ADDENDUM #1

RFP # 12-027

RFP for McInnish Irrigation Point of Connection Pump Project

August 1, 2012

Fields 6-9

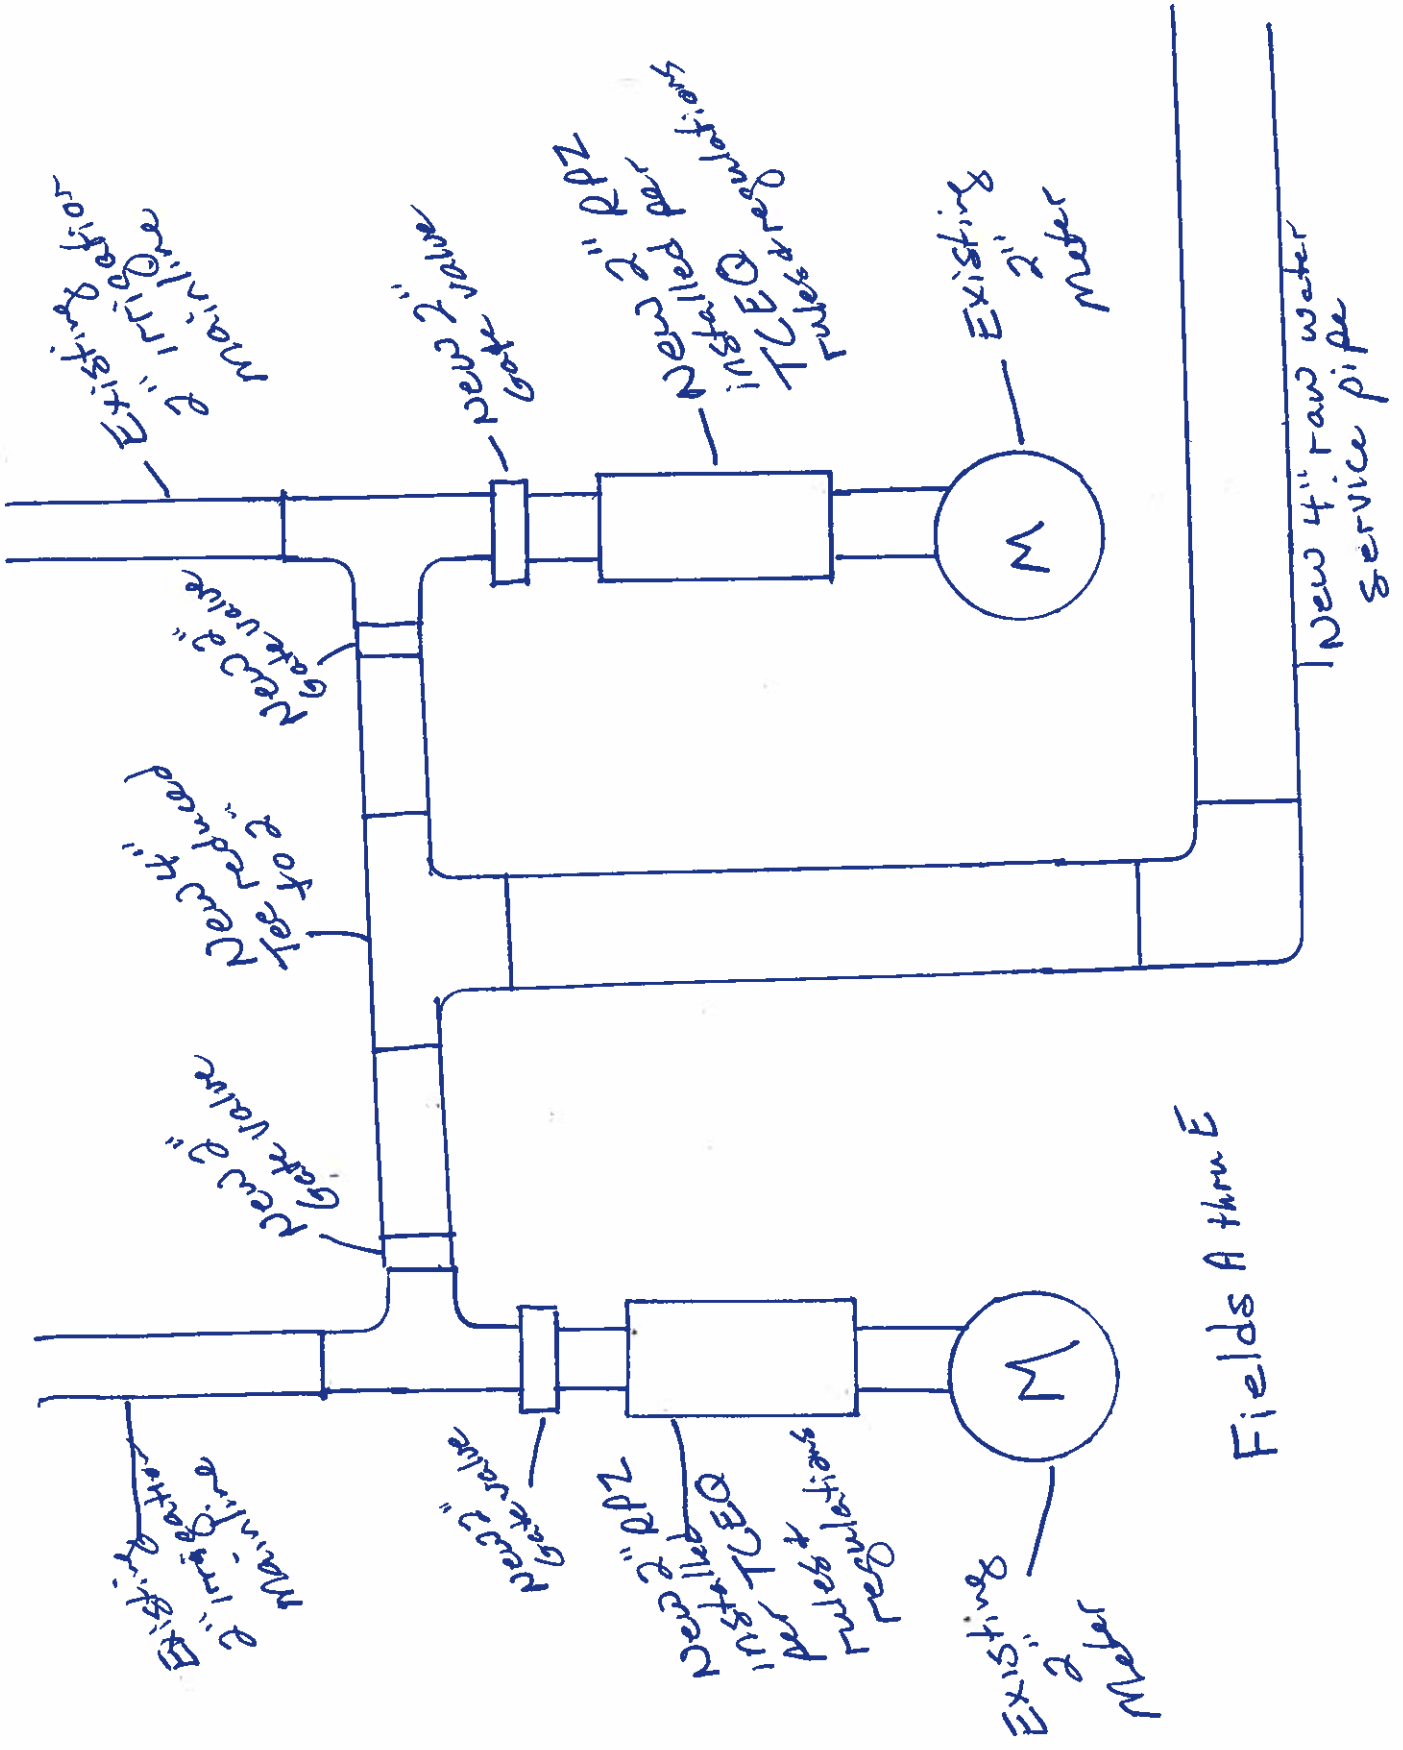
1. The bid due date and time remains the same for Thursday, August 9, 2012 11:00 AM
2. The removal of the previously listed backflow devices has been replaced with Reduced Pressure Zone (RPZ) assemblies. The RPZs will be supplied by the city and installed by the contractor. The new raw water connection will be made on the outlet side of the RPZ. This change will also allow use of the existing vault and will not require an additional vault at the connection point for fields 12-15 and will also eliminate the need for an air gap and the DI fittings at all connection points.
3. New Drawing and Maps have been provided
4. A replacement estimate of supplies has been provided; however it will be the vendor's responsibility for additional supplies and cost.

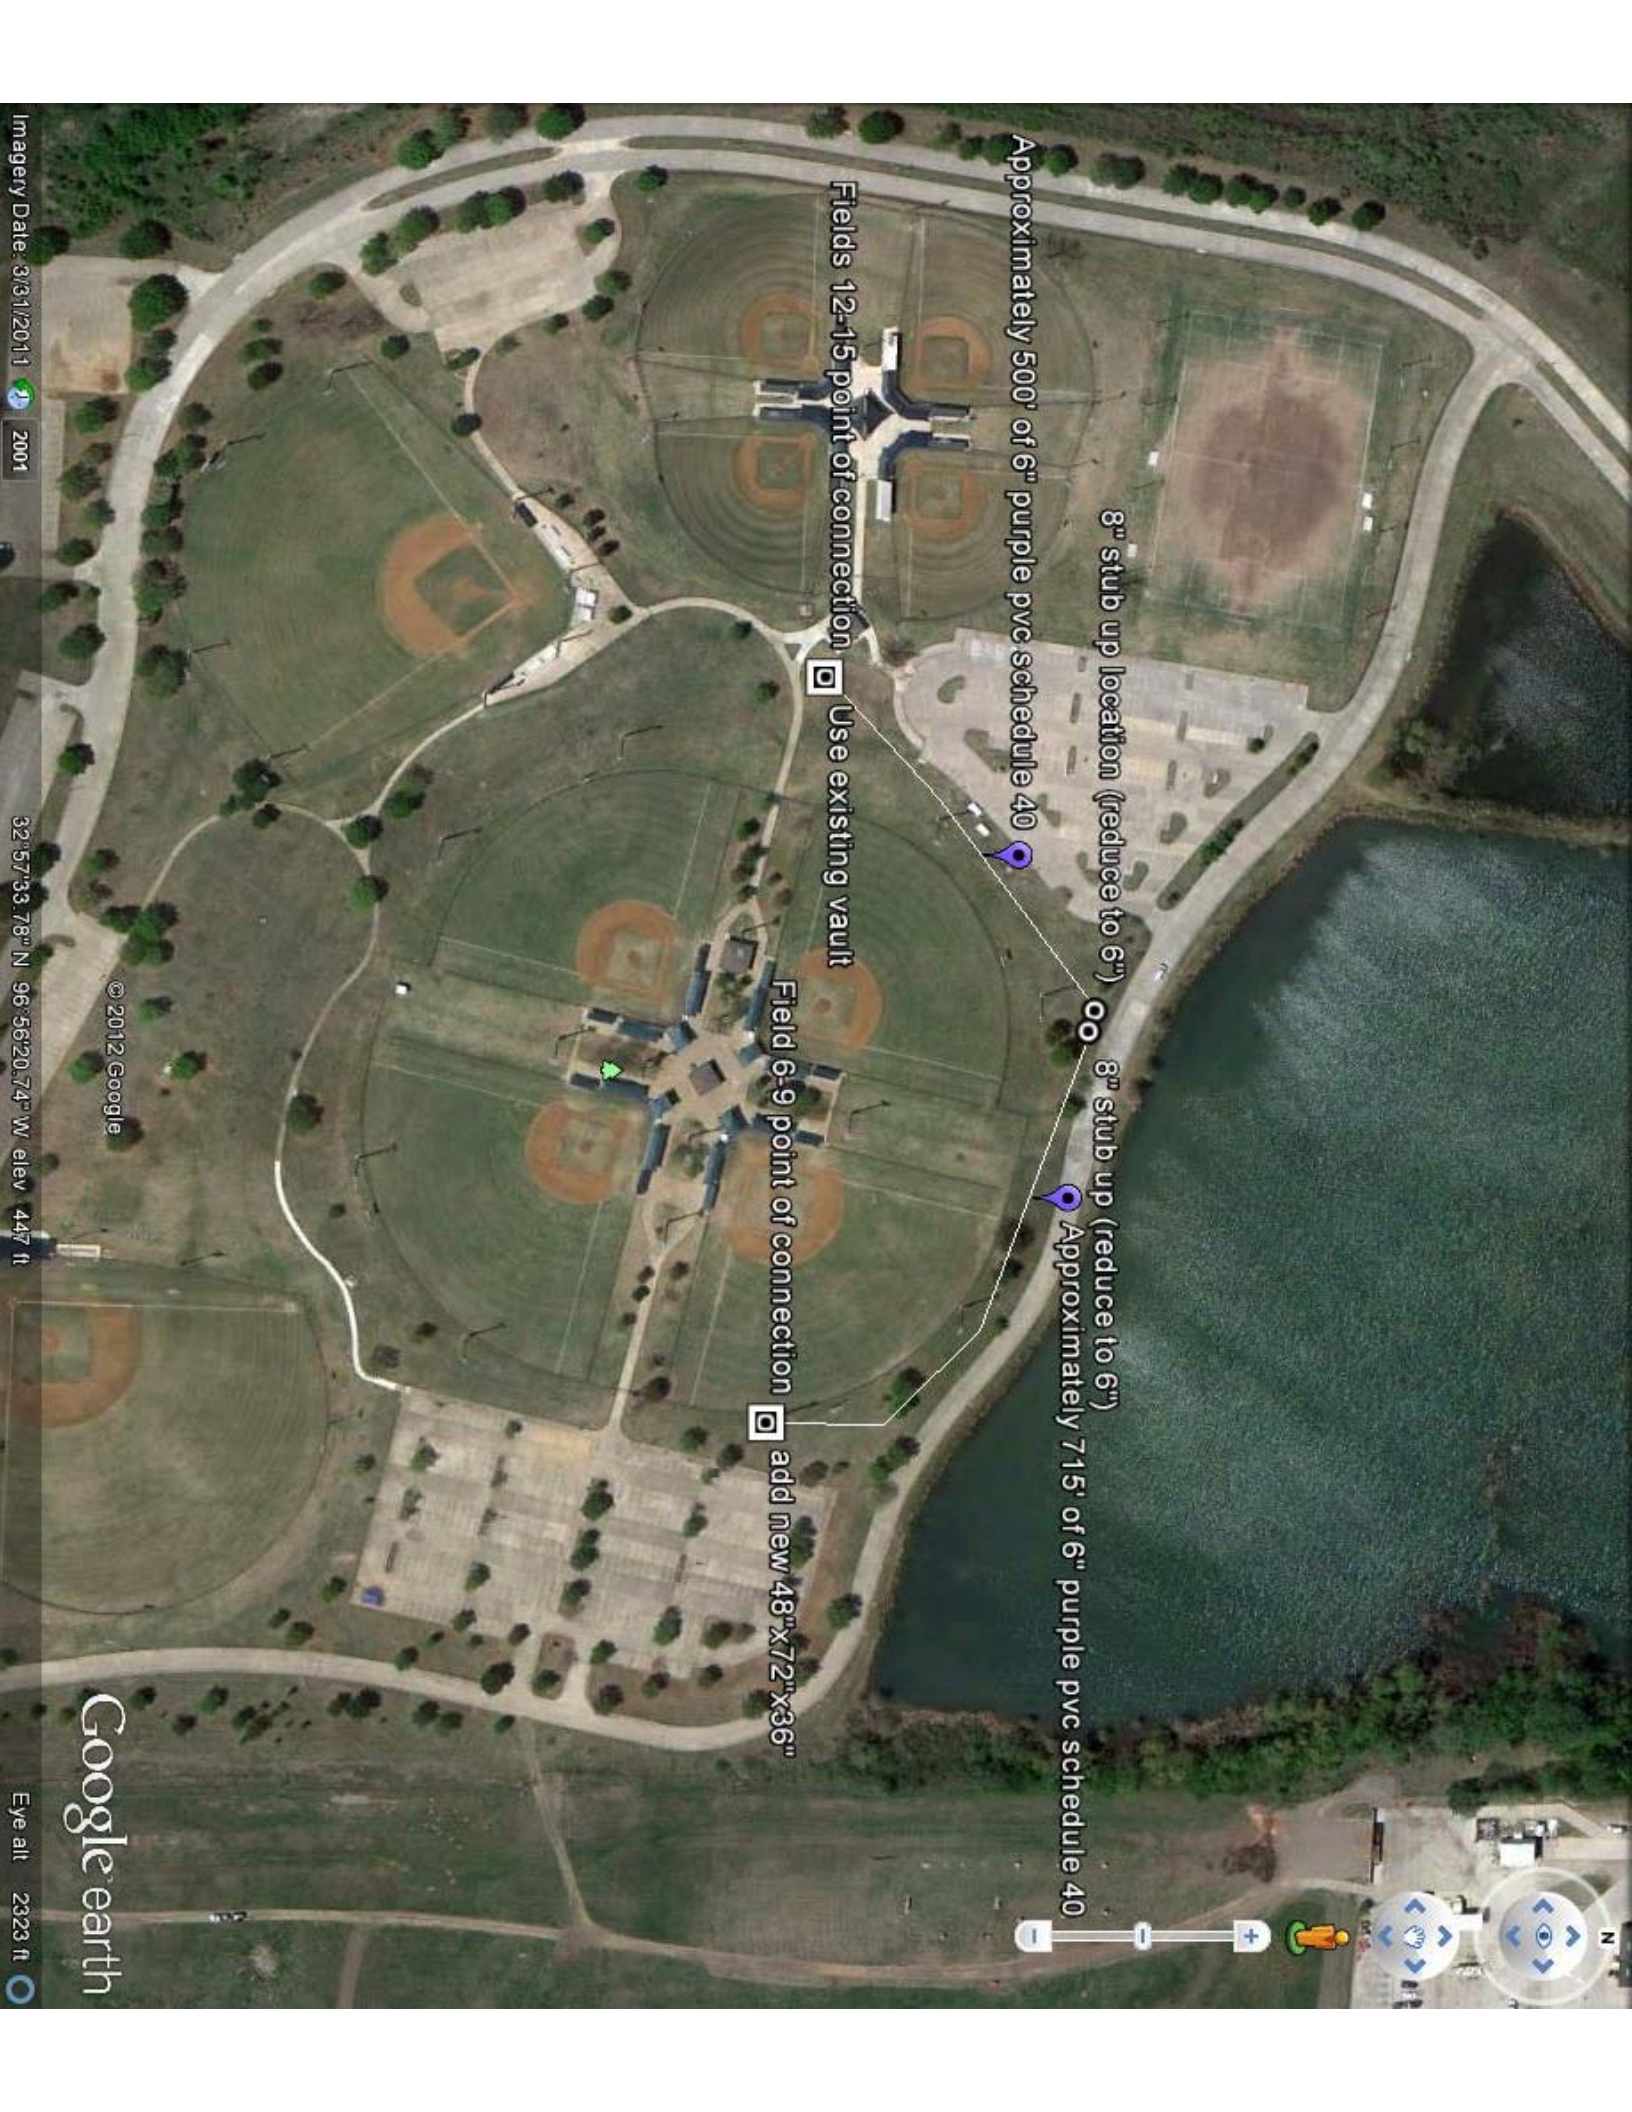
Approximately 500' of 4" purple pvc

8" stub up location (reduce to 4")

Approximately 500' of 6" purple pvc schedule 40

8" stub up location (reduce to 6")

8" stub up (reduce to 6")

Approximately 715' of 6" purple pvc schedule 40

Use existing vault

add new 48"x72"x36"
